LAND USE APPLICATION COMPLETENESS REVIEW

Subject Property: 1105 Front Street NE

Reference Nos.: 24-106451-PLN (Class 3 Site Plan Review, Tentative Subdivision Plan, Class 1 & 2 Adjustment, Class 2 Driveway Approach Permit)

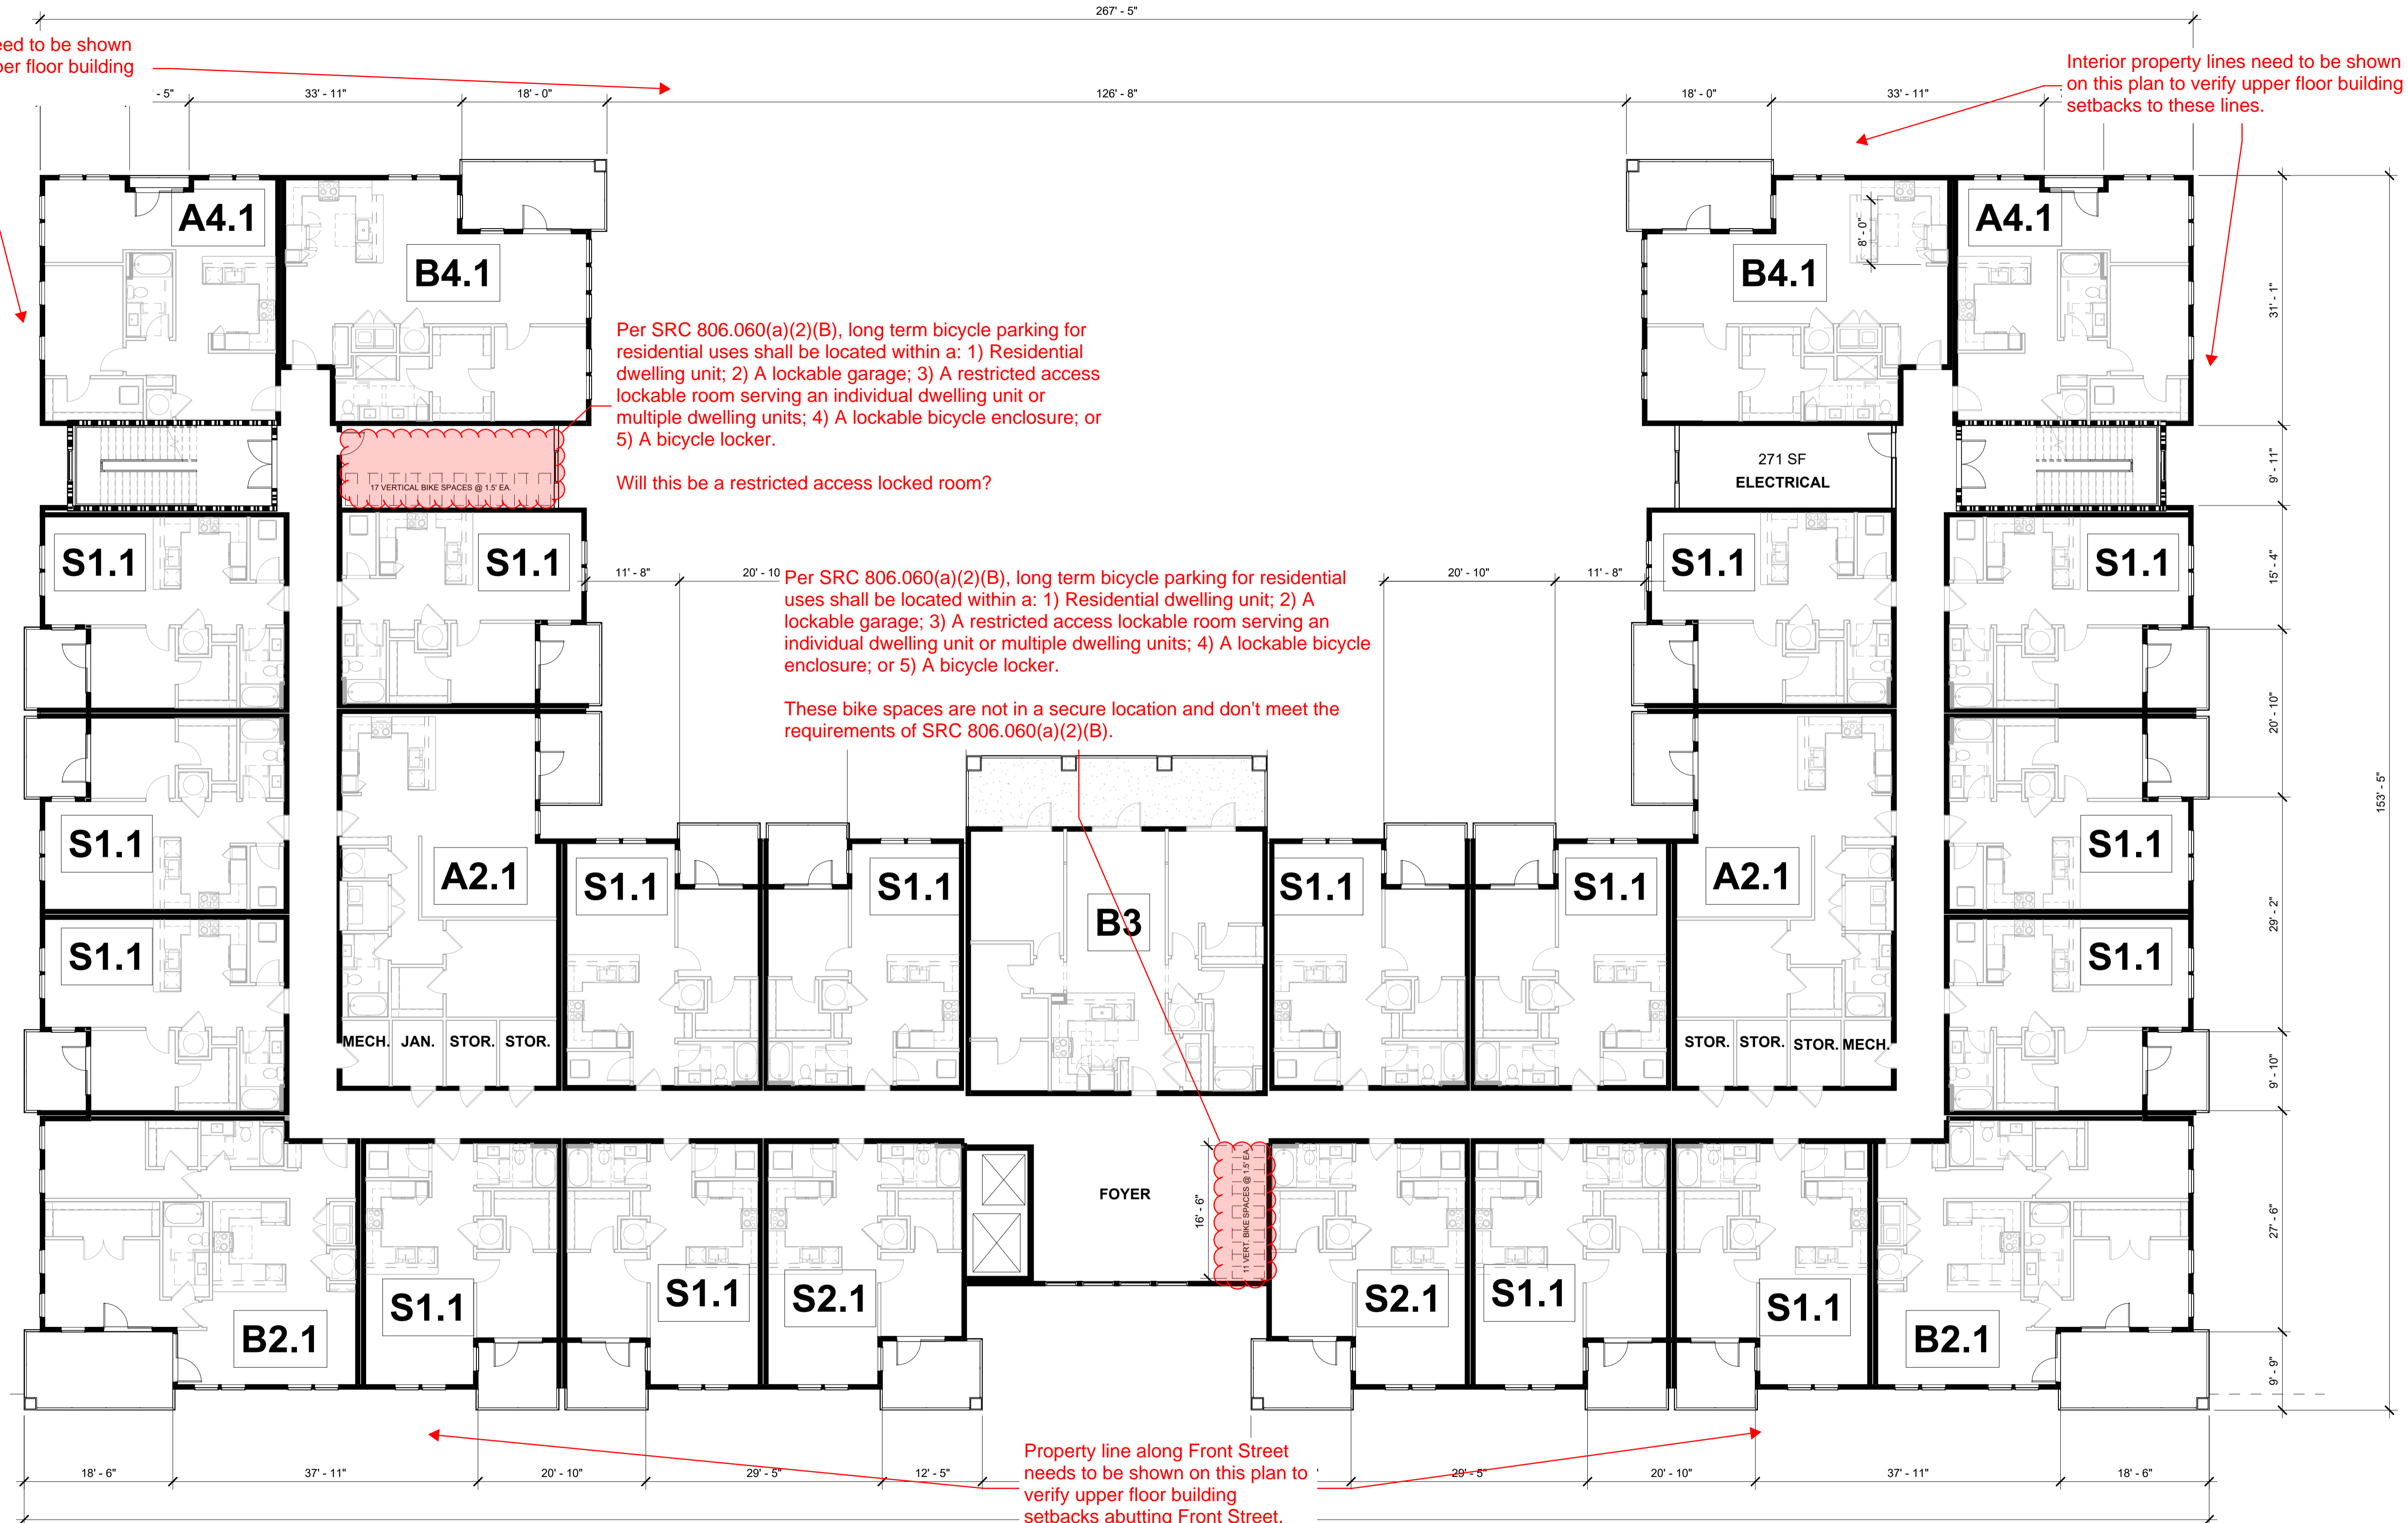
Interior property lines need to be shown on this plan to verify upper floor building setbacks to these lines.

Detail drawing needed showing the layout of each bike space in relation to the proposed vertical bike racks.

Per SRC 806.060(a)(2)(B), long term bicycle parking for residential uses shall be located within a: 1) Residential dwelling unit; 2) A lockable garage; 3) A restricted access lockable room serving an individual dwelling unit or multiple dwelling units; 4) A lockable bicycle enclosure; or 5) A bicycle locker.

These bike spaces are not in a secure location and don't meet the requirements of SRC 806.060(a)(2)(B).

Property line along Front Street needs to be shown on this plan to verify upper floor building setbacks abutting Front Street.

Interior property lines need to be shown on this plan to verify upper floor building setbacks to these lines.

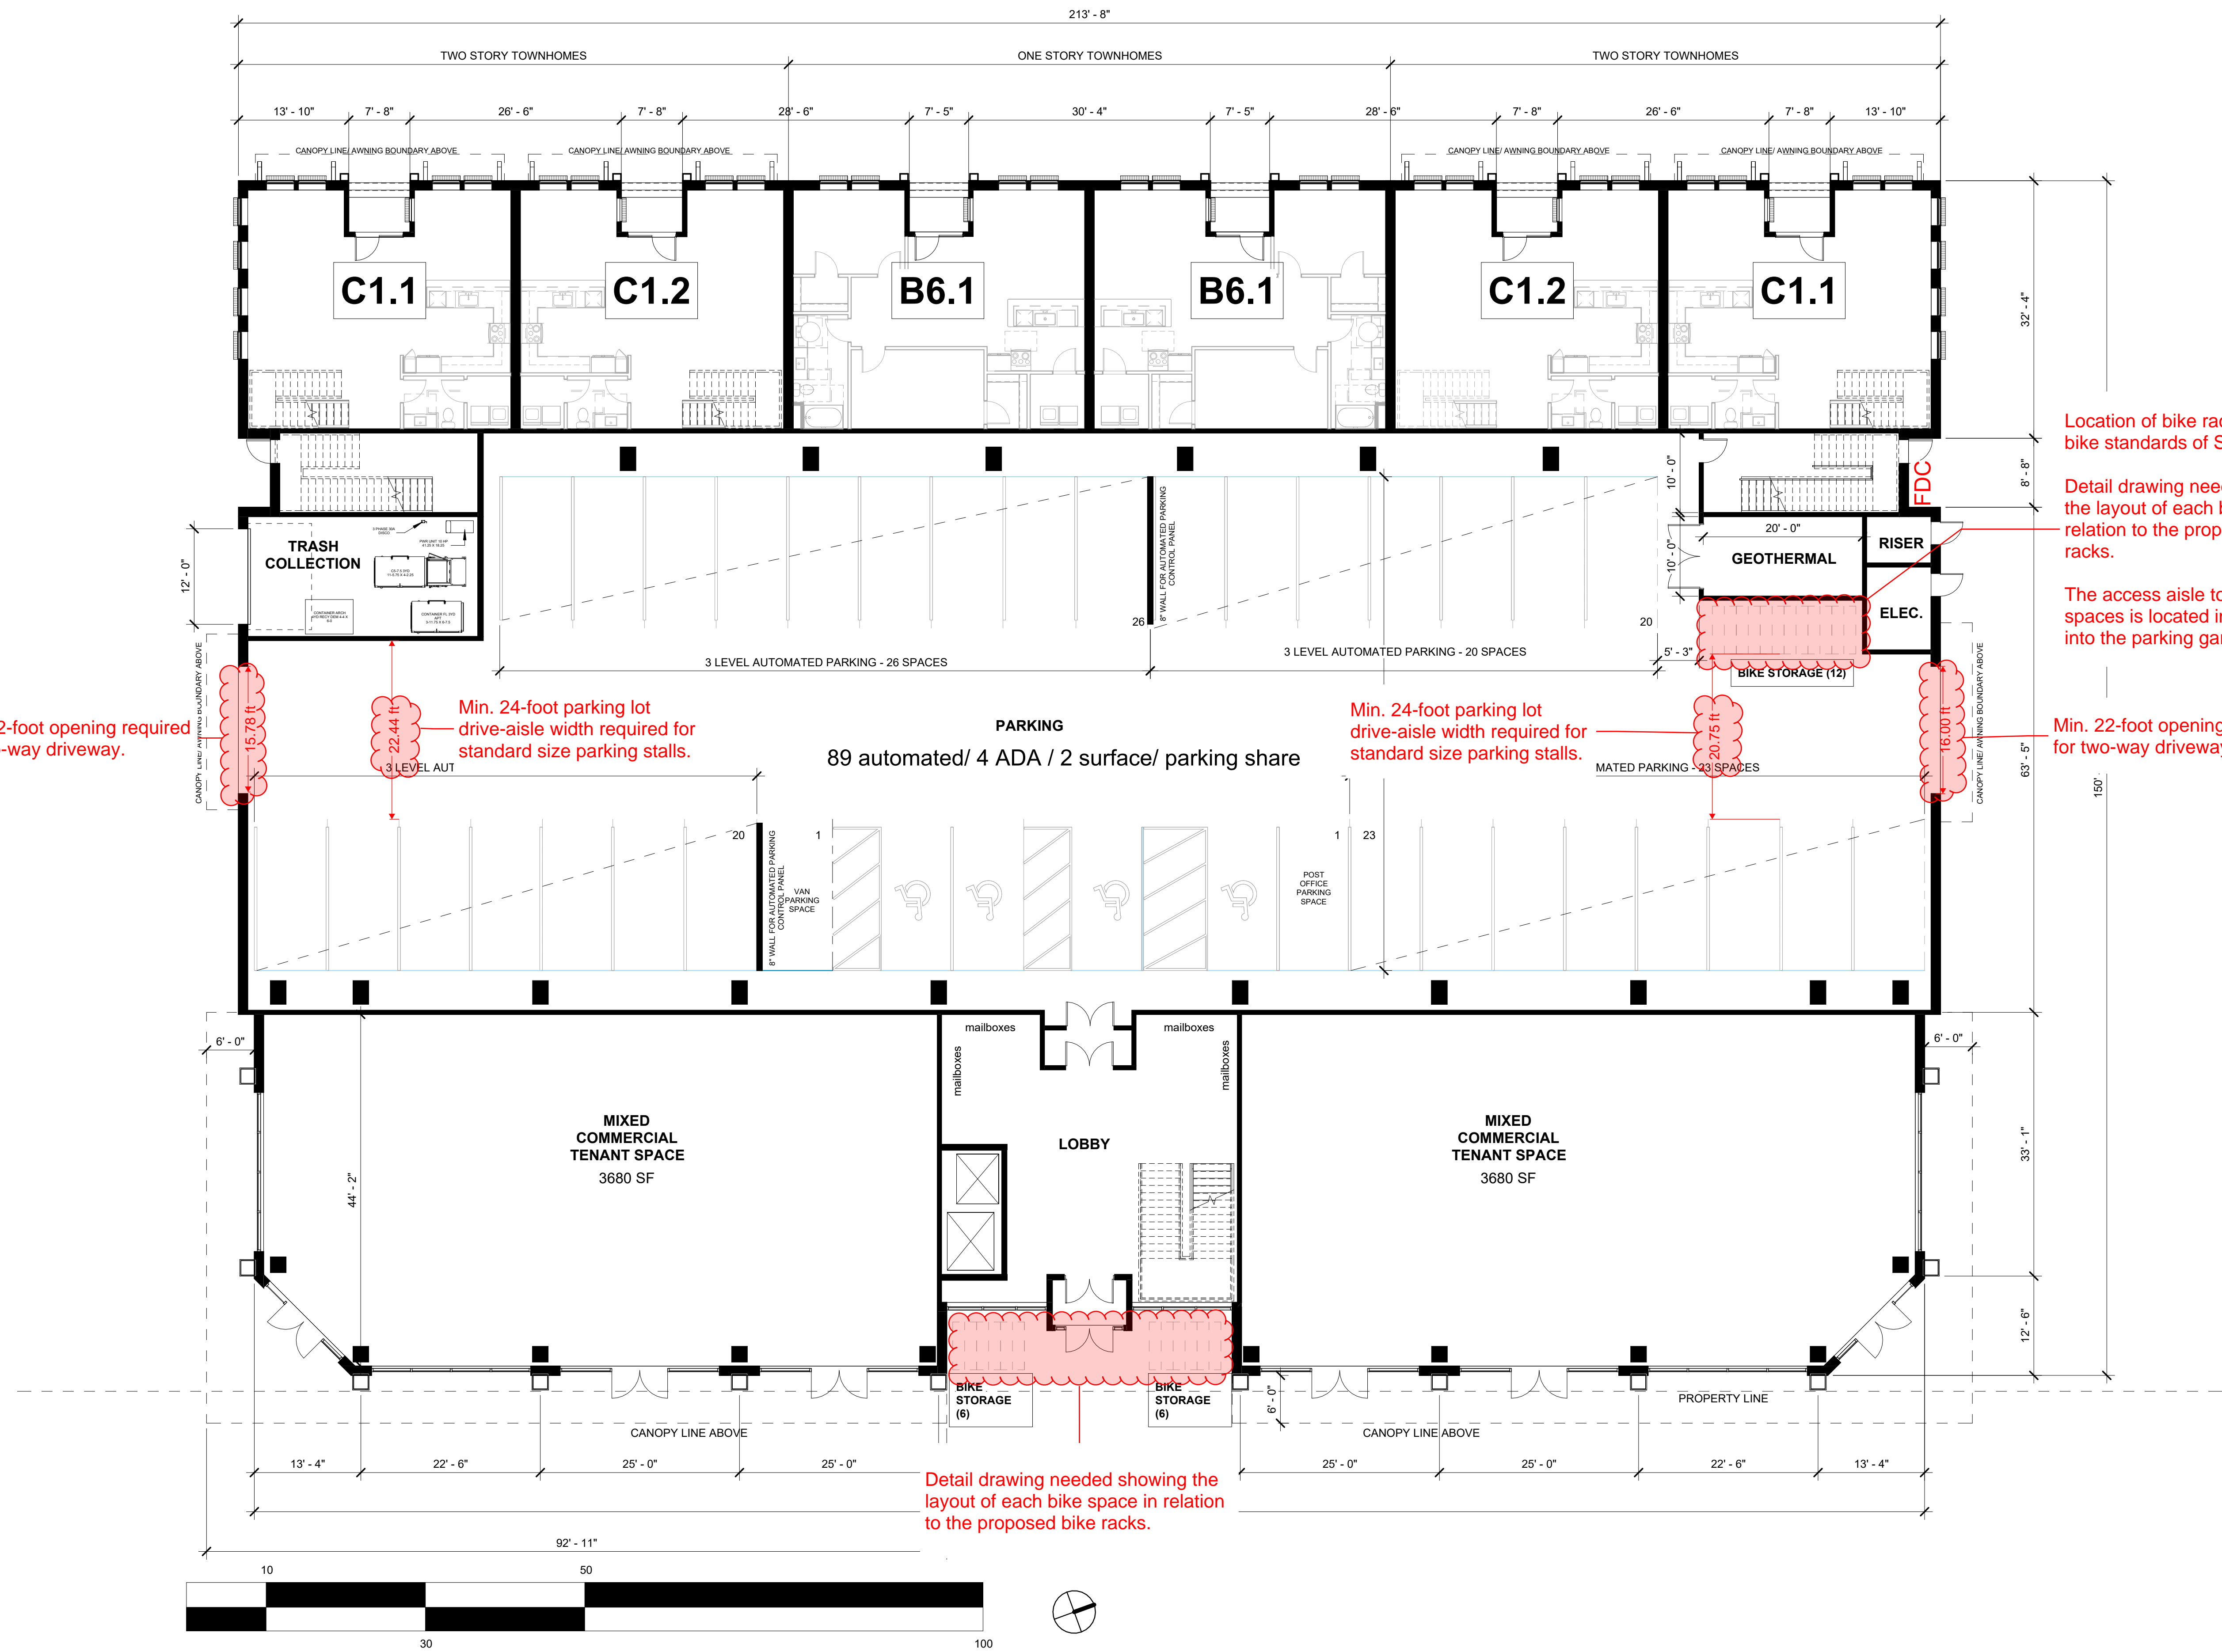
Interior property lines need to be shown on this plan to verify upper floor building setbacks to these lines.

Interior property lines need to be shown on this plan to verify upper floor building setbacks to these lines.

Interior property lines need to be shown on this plan to verify upper floor building setbacks to these lines.

Per SRC 806.060(a)(2)(B), long term bicycle parking for residential uses shall be located within a: 1) Residential dwelling unit; 2) A lockable garage; 3) A restricted access lockable room serving an individual dwelling unit or multiple dwelling units; 4) A lockable bicycle enclosure; or 5) A bicycle locker.

Will this be a restricted access locked room?

Per SRC 806.060(a)(2)(B), long term bicycle parking for residential uses shall be located within a: 1) Residential dwelling unit; 2) A lockable garage; 3) A restricted access lockable room serving an individual dwelling unit or multiple dwelling units; 4) A lockable bicycle enclosure; or 5) A bicycle locker.

These bike spaces are not in a secure location and don't meet the requirements of SRC 806.060(a)(2)(B).

Property line along Front Street needs to be shown on this plan to verify upper floor building setbacks abutting Front Street.
